Office Action Summary	Application No. 10/583,966	Applicant(s) YAGISAWA ET AL.	
	Examiner Aaron M. Dunwoody	Art Unit 3679

DETAILED ACTION

Fig. 3

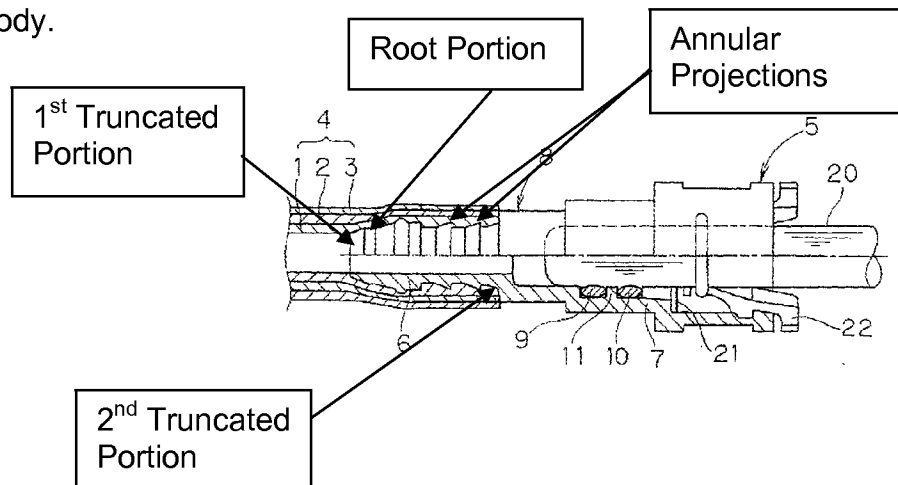
In regards to claims 1, 2, 4, 5, 7-10, 12 and 13, in Figure 3 below, Nishiyama et al disclose a resin tube-equipped quick connector for connecting a fuel- transporting resin tube (4) to a mating pipe, comprising a connector body (5), a retainer (22) and a seal member (9, 10); wherein the connector body has a generally tubular shape as a whole, and has a retainer holding portion at one axial side thereof, and also has at the other side thereof a press-fitting portion which is press-fitted into the interior of the resin tube from one end thereof, the press-fitting portion extends by a predetermined length L between a ring-shaped end face of the connector body and an ring-shaped end face of the press-fitting portion wherein the retainer is a member adapted to be held in the retainer holding portion, and is engaged with a convex or concave pipe-side engagement portion, formed on an outer peripheral surface of the mating pipe and

spaced from an axial insertion-side end thereof, so as to fix the inserted mating pipe in the axial direction; wherein the seal member is mounted within the connector body at an inner region thereof disposed closer to the press-fitting portion than the retainer holding portion is disposed, and the seal member is brought into contact with an outer peripheral surface of an insertion end portion of the inserted mating pipe disposed closer to the distal end of the mating pipe than the pipe-side engagement portion is disposed, thereby forming an air-tight seal between the insertion end portion and an inner surface of the connector body; and the resin tube including a press-fit undergoing portion into which the press-fitting portion is press-fitted, wherein before the press-fitting portion is press-fitted into the press-fit undergoing portion, when the press-fit undergoing portion is formed with an inner diameter that is substantially equal to an outer diameter of the root portions of the press-fitting portion, and after the press-fitting portion is press-fitted into the press-fit undergoing portion of the resin tube, the press-fit undergoing portion is adapted to cause portions of its inner diameter facing the root portions to become equal to the outer diameter of the root portions, so that and the press-fit undergoing portion is integrated with the press-fitting portion in a withdrawal-preventing condition, wherein the press-fitting portion is provided along the length L with the following portions, one immediately after another: a first truncated-conical-shaped portion extending from the ring-shaped end face; a cylindrical-shaped root portion, the plurality of truncated-conical-shaped annular projections each followed by a ring-shaped face and another cylindrical-shaped root portion, a second truncated-conical-

shaped portion, which ends abutting with the ring-shaped end face of the connector body.

Nishiyama also includes an insert portion (6). It would have obvious to one having ordinary skill in the art at the time the invention was made to omit the insert portion (6), since the omission of an element and its function in a combination, where the remaining elements perform the same functions as before, involves only routine skill in the art. In re Kuhle, 526 F.2d 553, 188 USPQ 7 (CCPA 1975); In re Karlson, 311 F.2d 581, 136 USPQ 184 (CCPA 1963).
